**Re: 25 Forge Parkway
Site Plan -3rd Peer Review**

BETA Group, Inc. is pleased to continue our engineering peer review services for the proposed project entitled "**Site Development Plans for 25 Forge Parkway**" located at 25 Forge Parkway in Franklin, Massachusetts. This letter is provided to outline findings, comments, and recommendations.

RE: Site Plan Modification – Warehouse Addition, #25 Forge Parkway

A&M Project #: 2712-02
Re: 25 Forge Parkway
Industrial/Warehouse
Response to
Review Comments

DRAWING TITLE: TRUCK TURNING FIGURE
 SHEET No. 1
 Copyright © 2023 Allen & Major Associates, Inc. All Rights Reserved

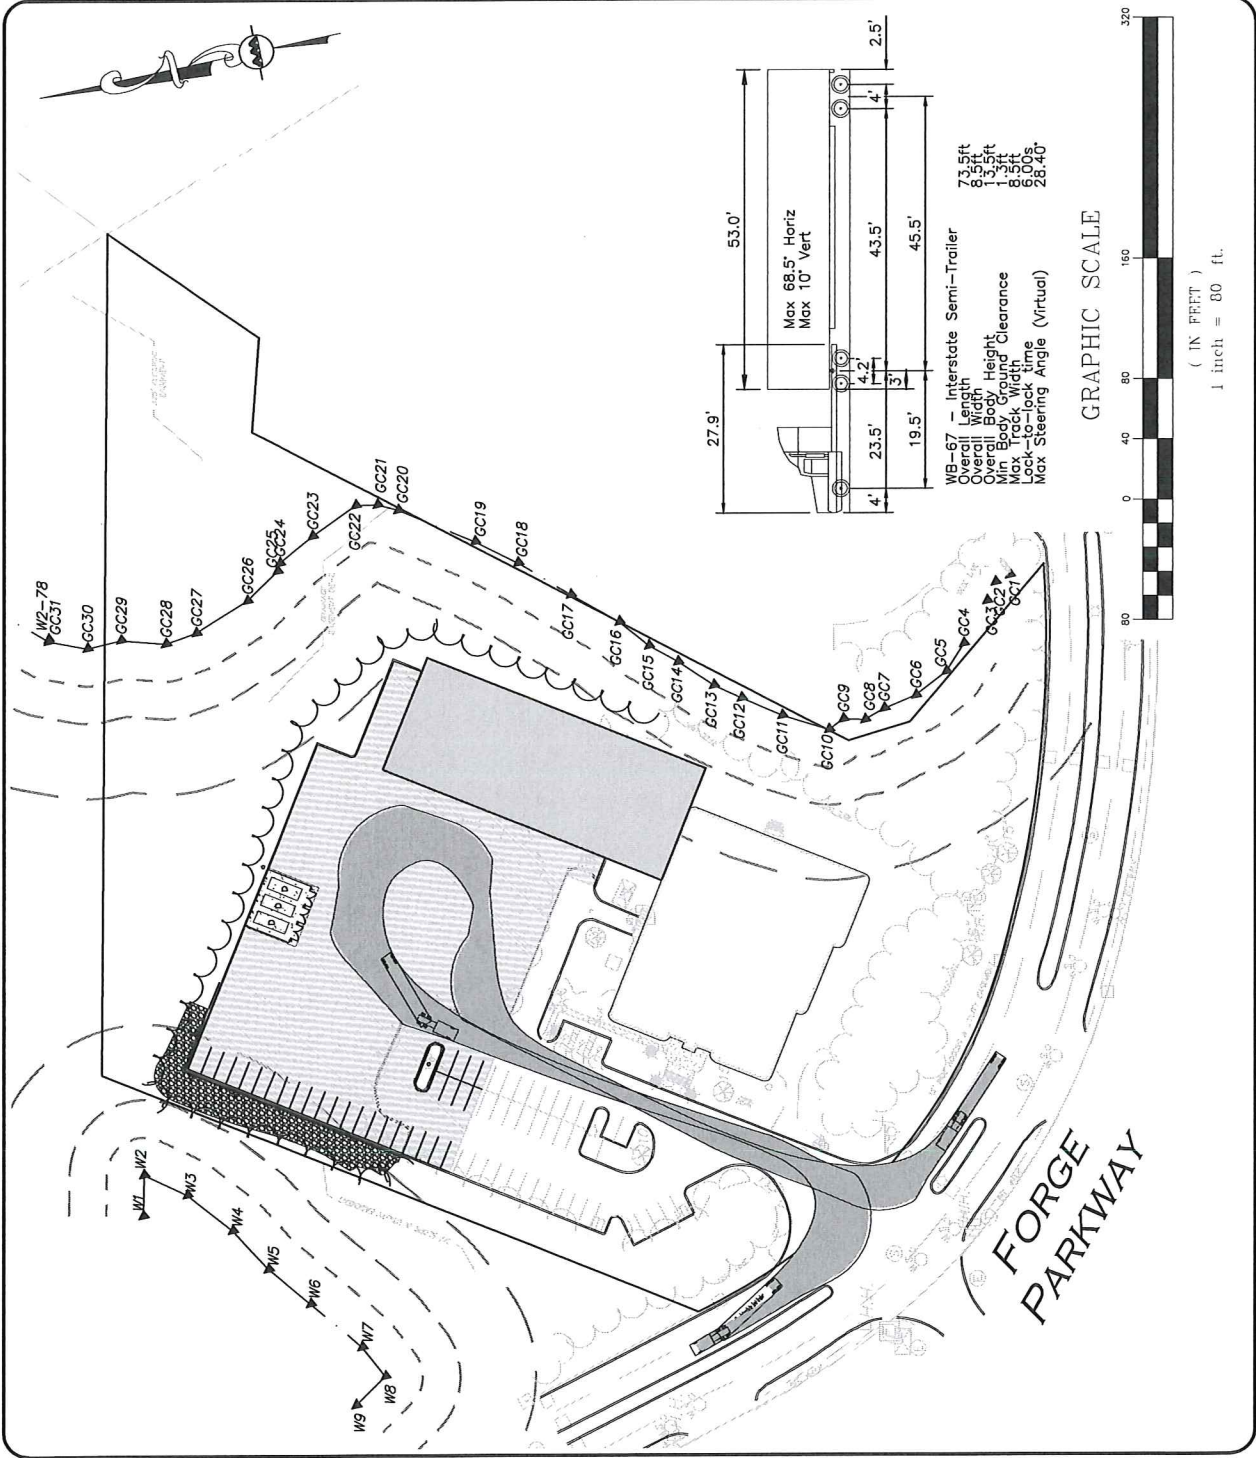
SP3. The use of the site is being converted from office to warehouse. BETA recommends that truck turning movements at the entrance for the tractor trailers anticipated be shown and site distances identified to determine whether some trimming of vegetation is needed along Forge Parkway to maintain sight distances, especially to the east.

A&M Response: Forge Parkway is a private road with a posted speed limit of 20 miles per hour (MPH). The stopping sight distance determined by AASHTO for a 20 MPH zone is 115 feet. We've added dimensions to the Layout & Materials Plan which illustrate that a sight distance of 115 feet is available from the site driveway exit. A truck turning figure is provided with this letter which illustrates that a WB-67 is able to maneuver through the site.
